Planning Commission Study Session

SUBJECT: DR22-155 INDUSTRIAL FLEX BUILDING

DR22-155 Industrial Flex Building: Site plan, landscaping, grading and drainage, elevations, floor plans, lighting, and colors and materials for approximately 0.68 acres, generally located west of Cooper Road and south of Baseline Road and zoned Light Industrial (LI) with a Planned Area Development (PAD) overlay.

DR22-155 Industrial Flex Building Attachment 6: Building Elevations

ELEVATIONS

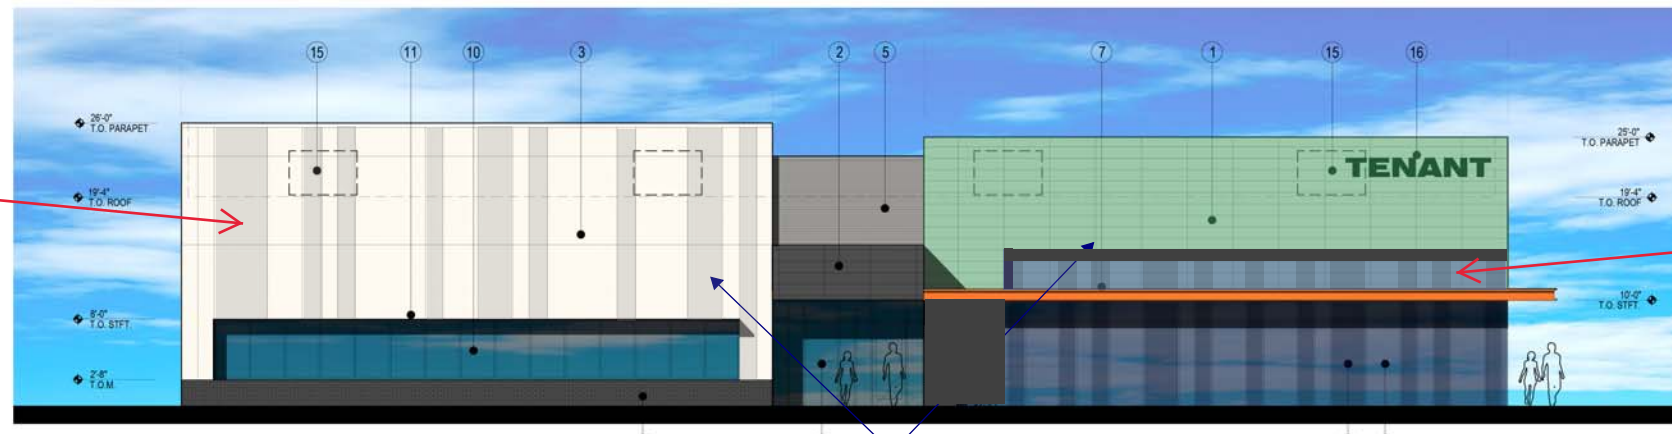
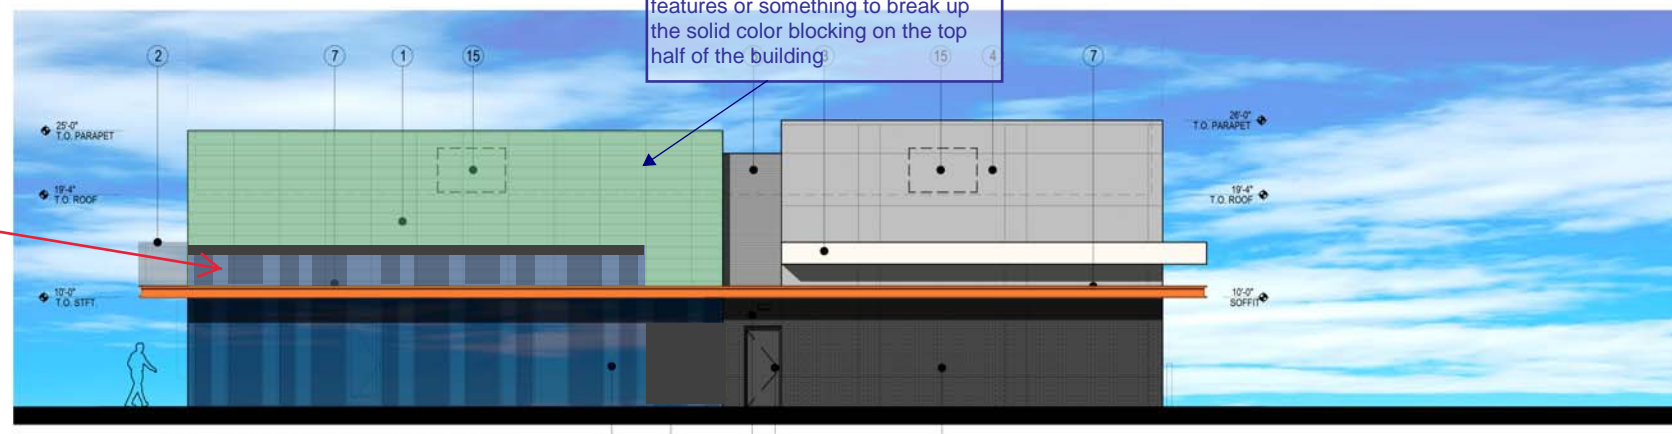
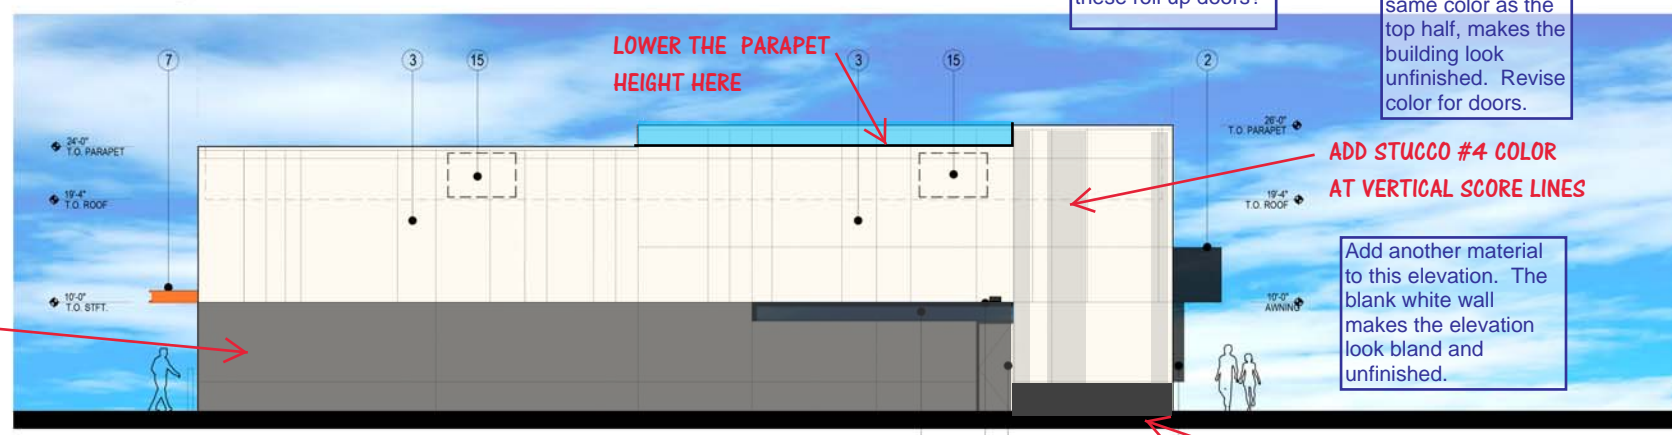
Can you provide me with a brief explanation on why you chose these colors? Are they corporate colors or just preferred?

These elevations need something. Add an additional canopy or accent features or something to break up the solid color blocking on the top half of the building.

NOTE: Ensure that canopy signs have a way to be mounted without a visible raceway. Raceway cannot be mounted on top of the canopy or on the front of the canopy and must be completely hidden from view.

FLOOR PLAN
1/8" = 1'-0"

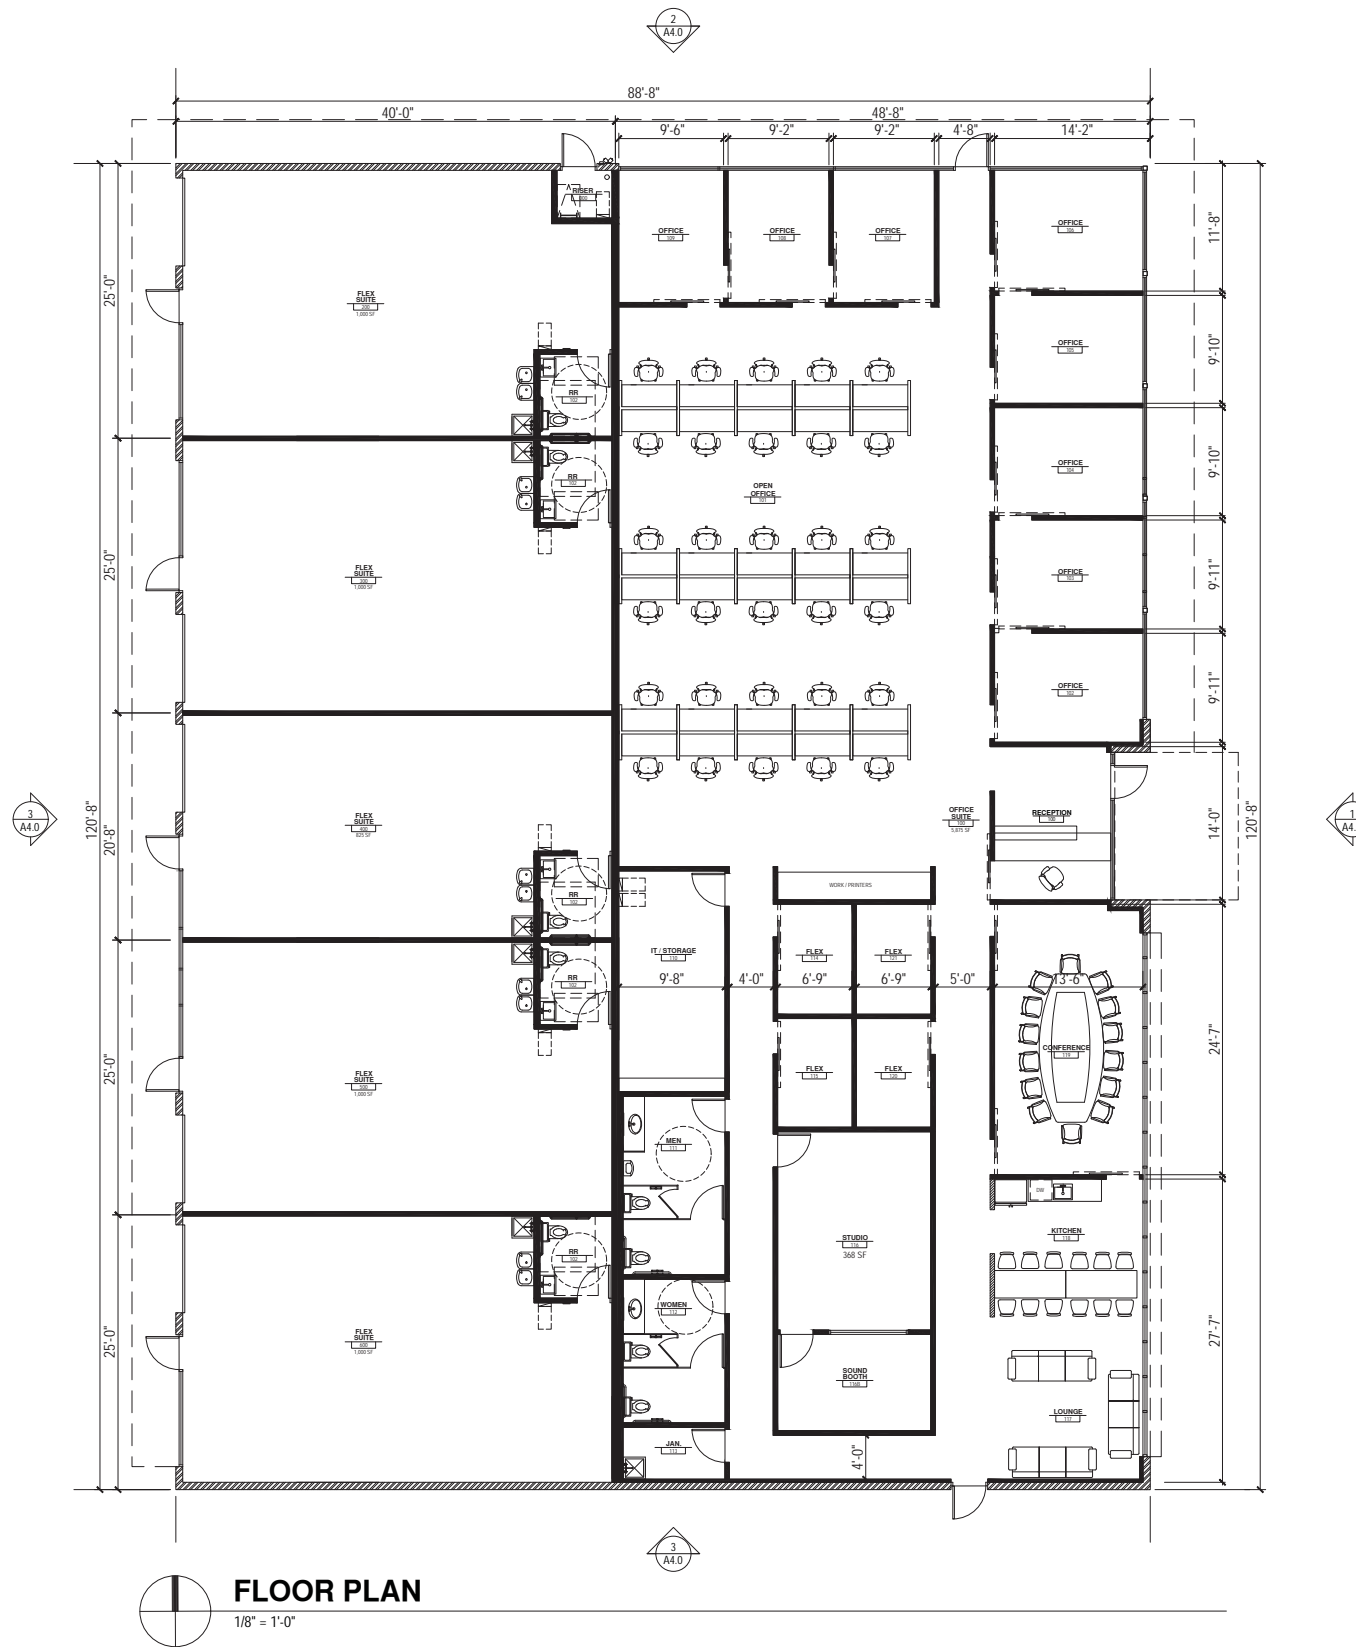
office space on the eastern half and flex space on the western half. Currently, there is not an internal connection between the two halves. Staff has encouraged the applicant to add internal connections, so the two halves are more integrated. This will better assist with the proposed parking layout as well. As proposed, there are only six parking spaces located on the west side of the building to serve the 4,800 sf of flex space. If those spaces are full, patrons would need to park in the eastern parking lot and walk around the exterior of the building to get to the entrances of the flex spaces.
